Service Bulletin No.: DA20-32-04 Rev 1
(supersedes DA20-32-03 Rev 0)

Date Issued: 09 JUN 2008

Title: Inspection of NLG Elastomer Spring and
Installation of Replacement Elastomer Elements

**Figure 1 - NLG Spring after Assembly
(NLG Strut not shown)**

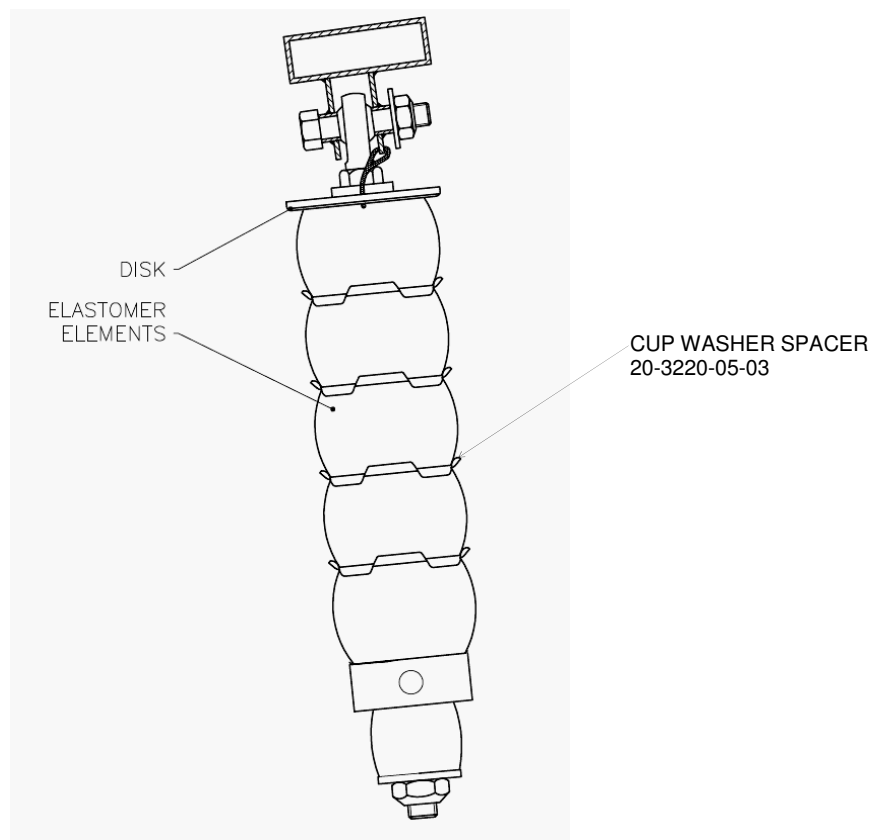
- 10.3.1** Remove engine cowlings in accordance with AMM.
- 10.3.2** Inspect NLG elastomer spring assembly for shrinkage or damage of the elastomer elements and damage to the cup washer spacers, part number 20-3220-05-03.
- 10.3.3** Push down on fuselage in front of vertical stabilizer to hold nose landing gear above the ground.
- 10.3.4** Push elastomer elements down until seated. If there is no gap between the elastomer springs and the disk (Figure 1), check for other possible causes for reduced propeller clearance such as a bent or damaged nose landing gear strut.
- 10.3.5** If there is a gap, proceed to Part 4.

- 10.4.1** Replace all five elastomer elements with five replacement elements, part number DV2-9032-23-01. Refer to AMM Chapter 32-20 page 4 and 5 for replacement instructions. If the two spacers 20-3220-05-07 were installed per service bulletin DA20-32-03 (at the bottom of the strut assembly), remove them.
